Addendum No. 001

Subject: William Rowen School – Classroom Modifications
SDP Contract Nos. B-063C, B-066C of 2017/18

This Addendum, dated May 9, 2018, shall modify and become part of the Contract Documents for the work of this project. Any items not mentioned herein, or affected by, shall be performed strictly in accordance with the original documents.

DRAWING NO.
ED121

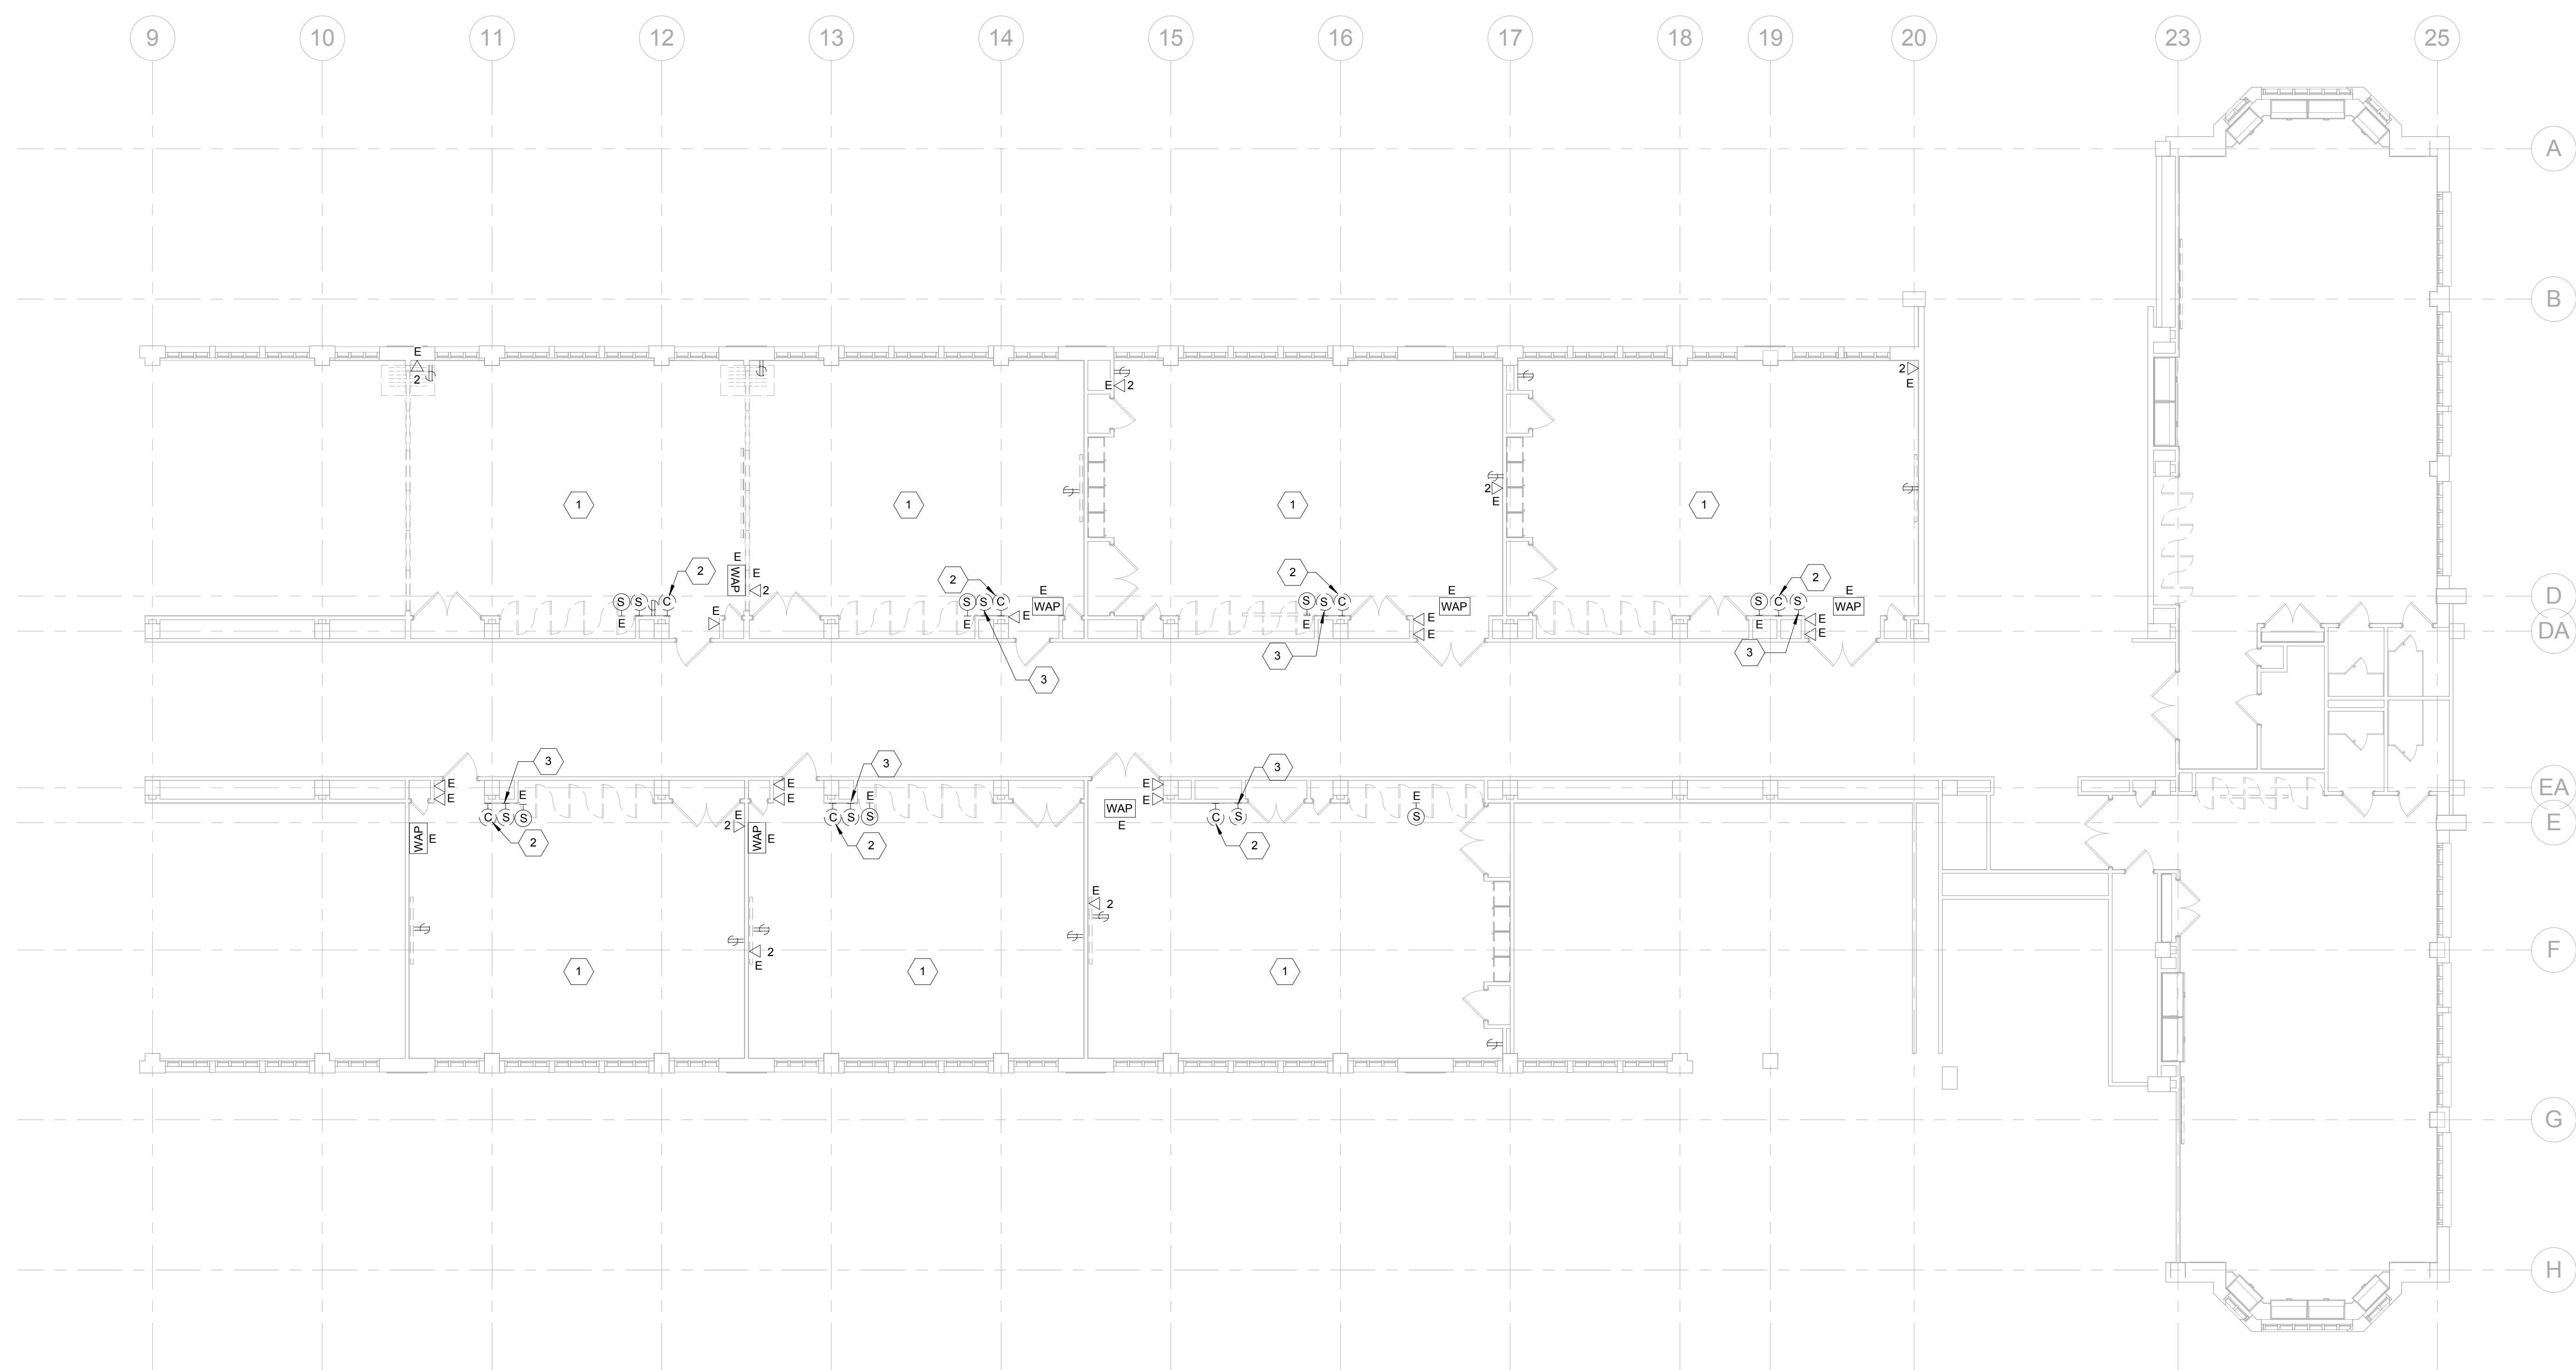
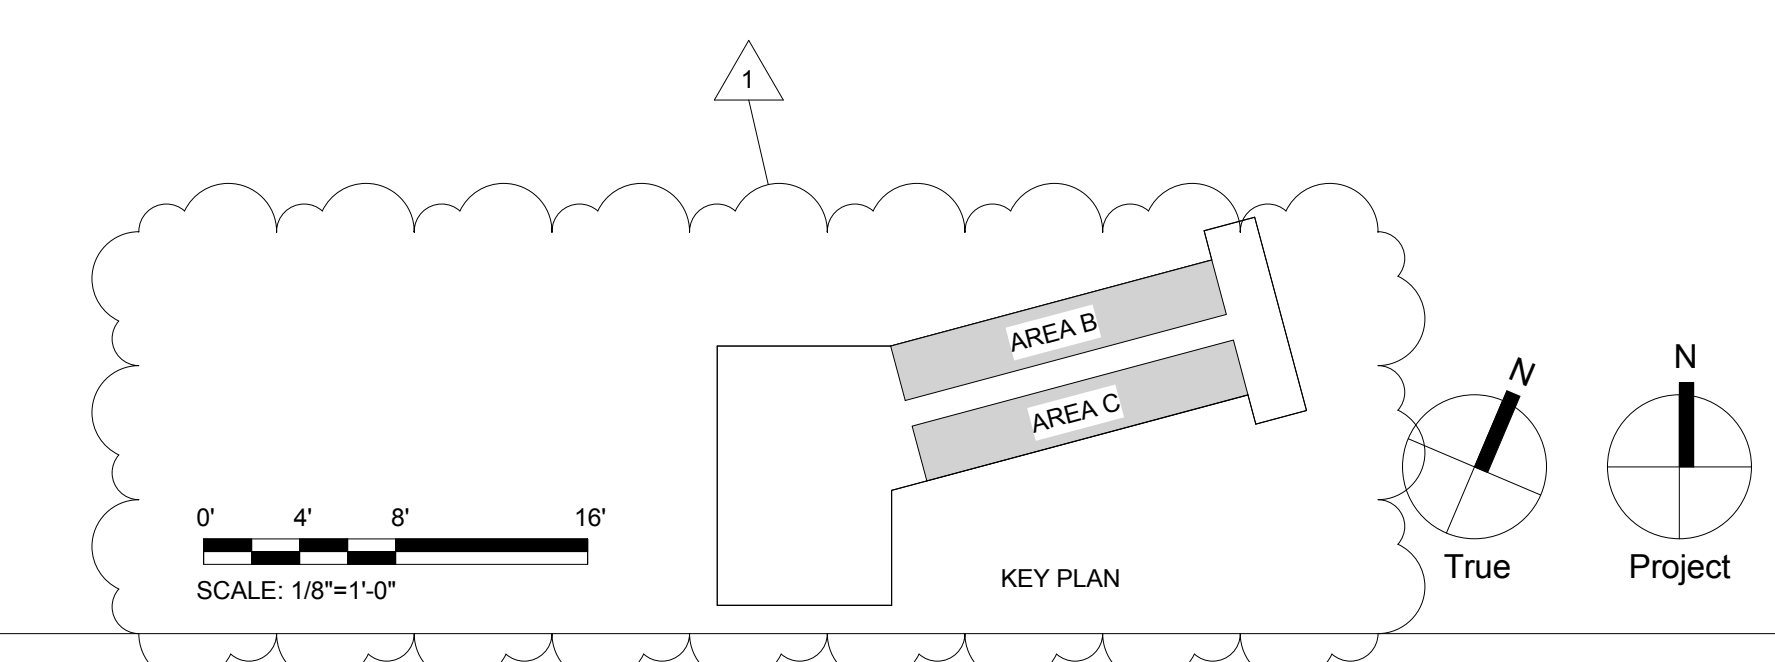
- a. Add Key plan

DRAWING NO.
ED122

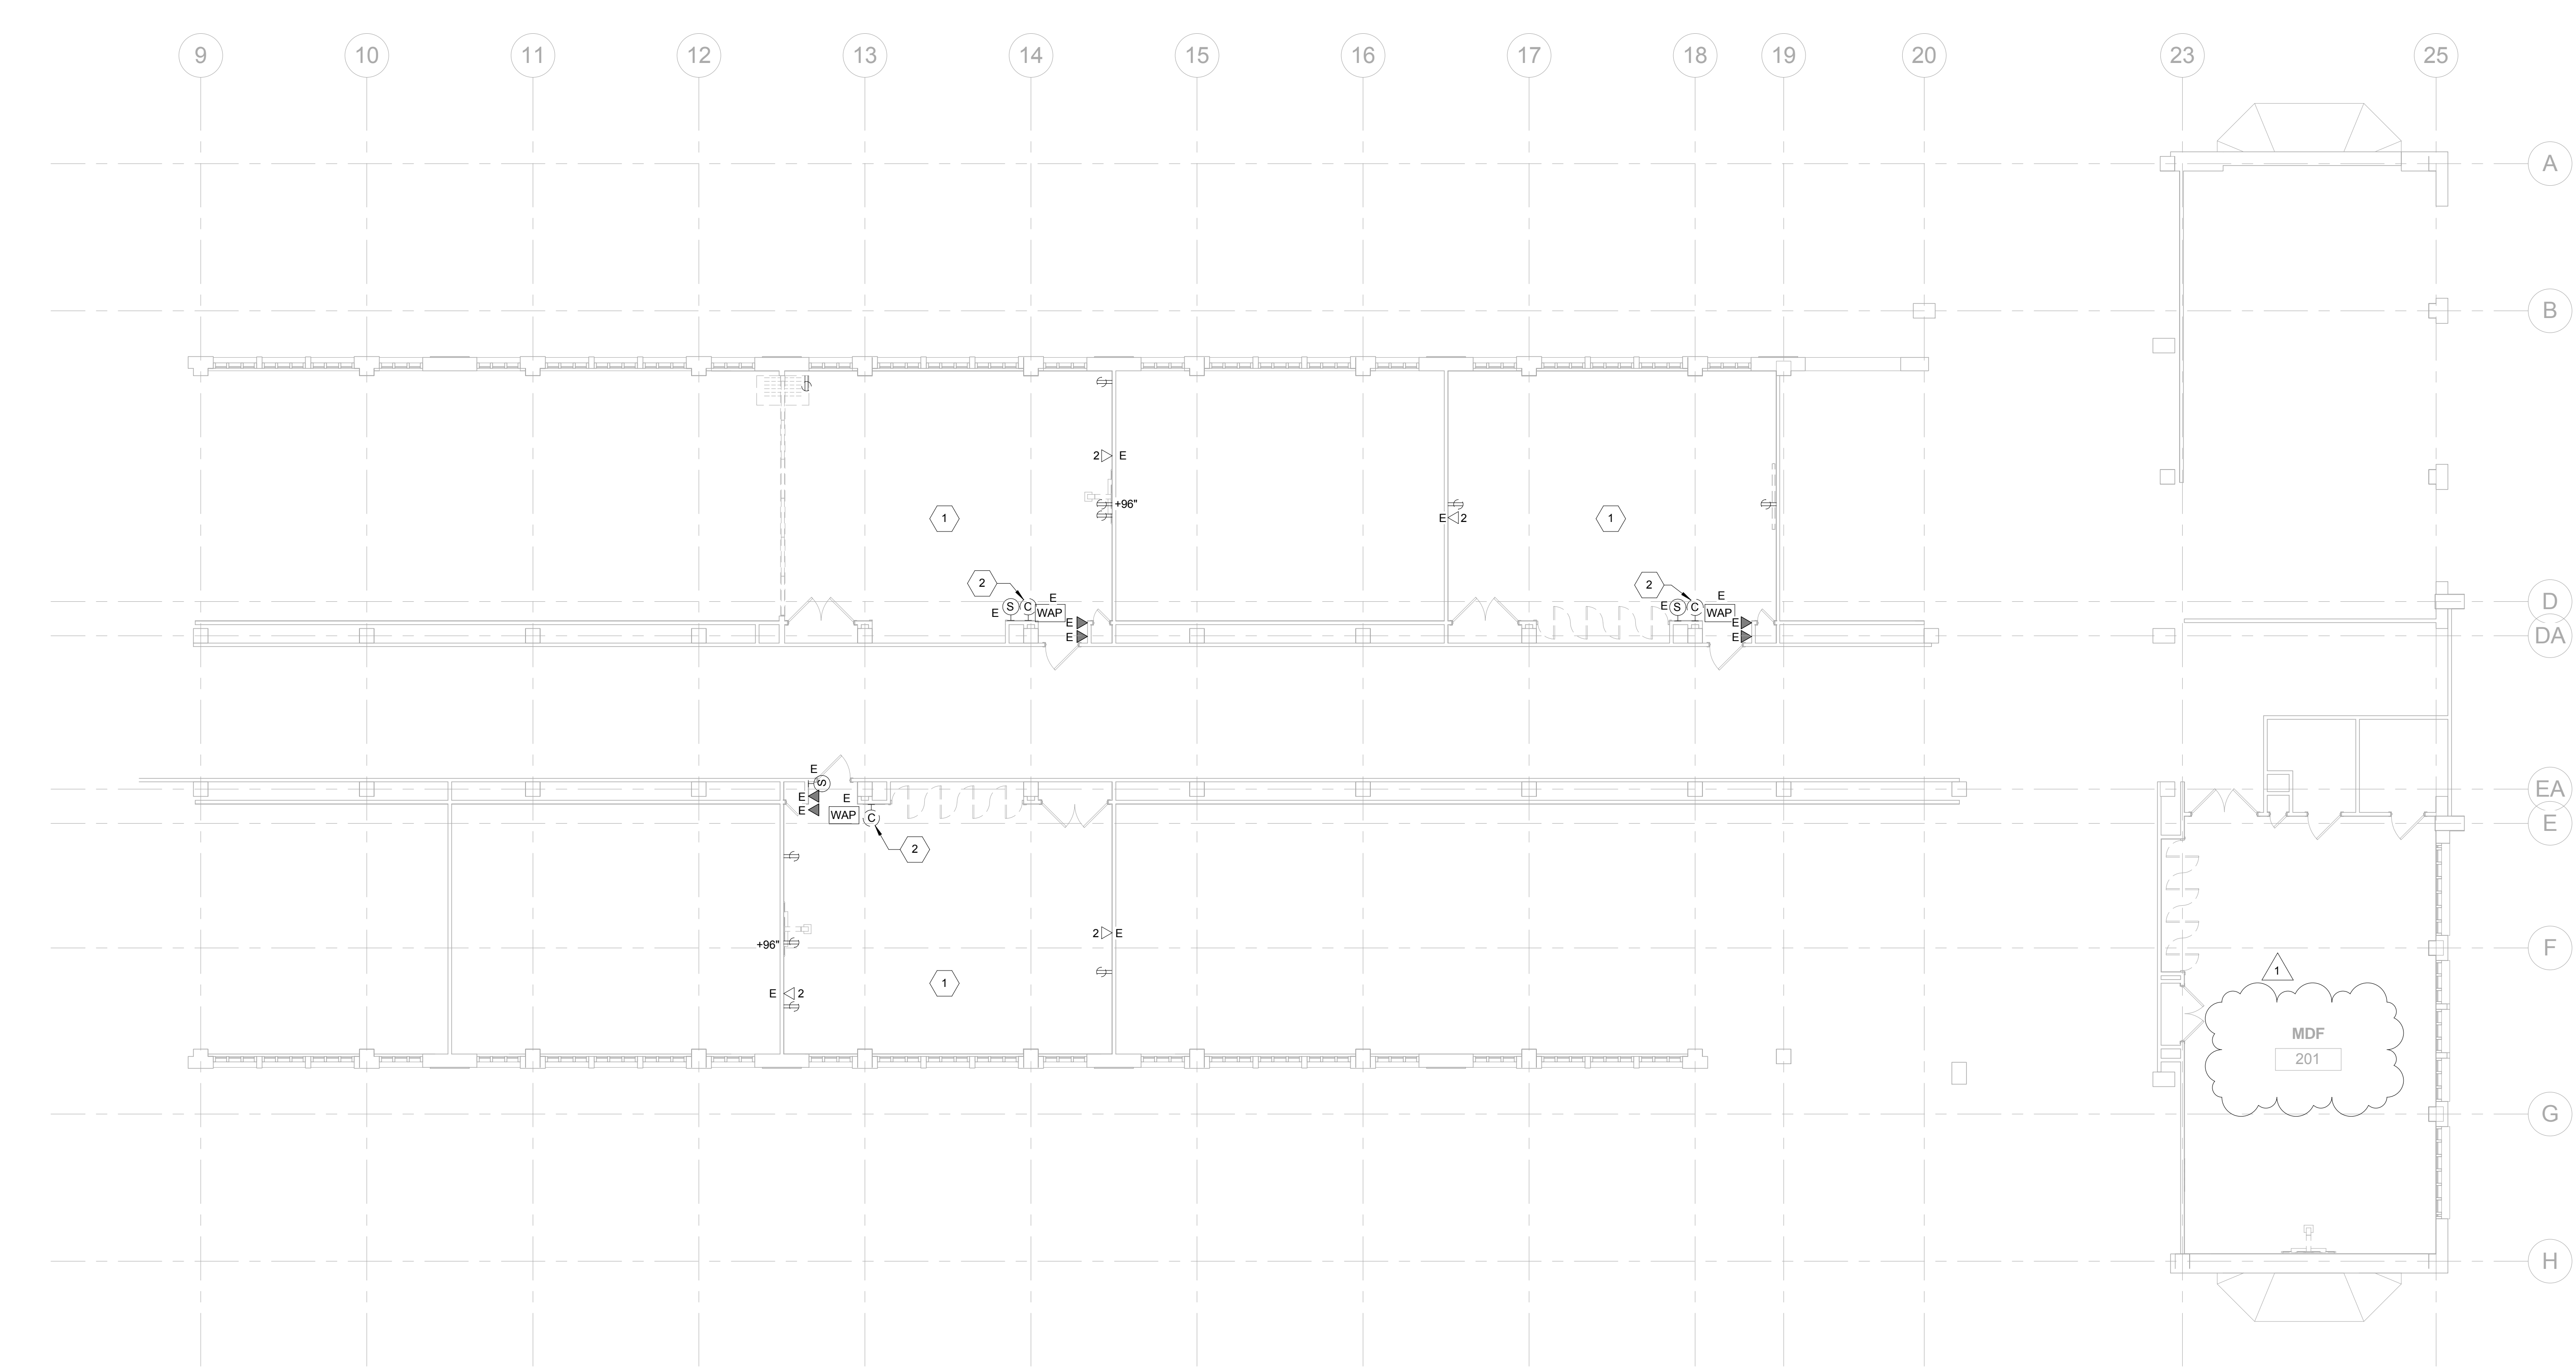
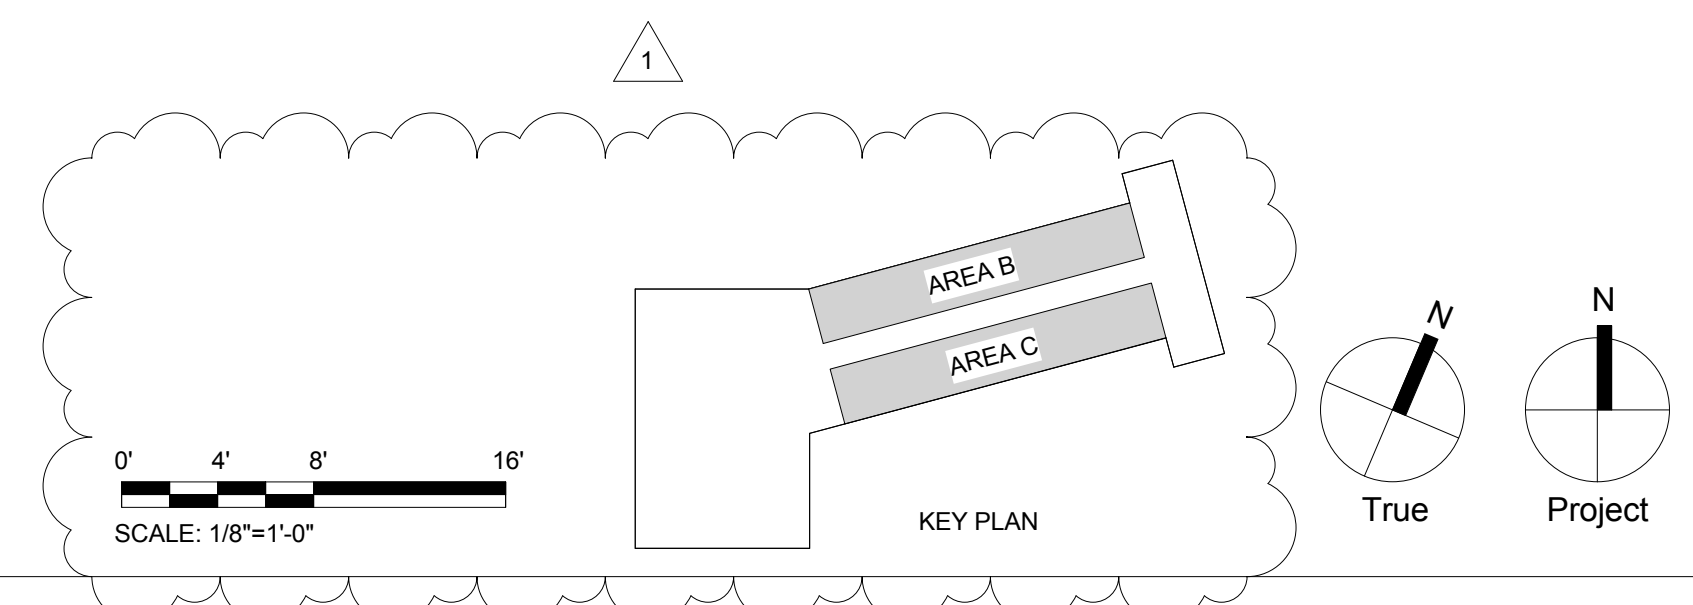
- a. Added MDF room 201.
- b. Add Key plan.
